Product Change Notification

Change Notification #: 110909 - 01
Change Title: Intel® Desktop Board DZ68DB, Boxed and Bulk
PCN 110909-01, Product Material
Replace PWM CONTROLLER
Reason for Revision: Add CPU Socket Cover change
Date of Publication: August 10, 2011

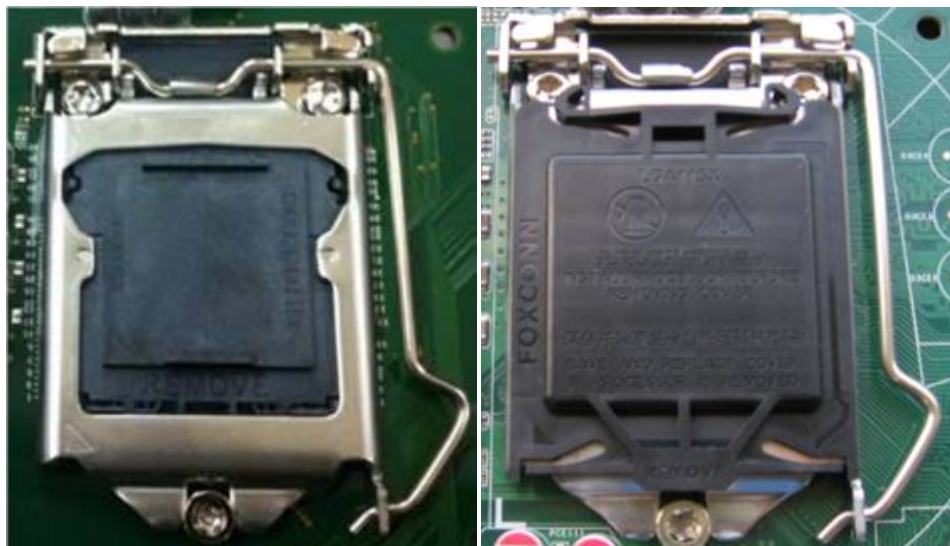
1. The Pulse Width Modulation controller CHIL 8104 upgraded from version E4 to E5 to enhance performance.
2. The CPU socket cover will be changed to the ILM version.

Current socket with PNP cover

New socket with ILM cover
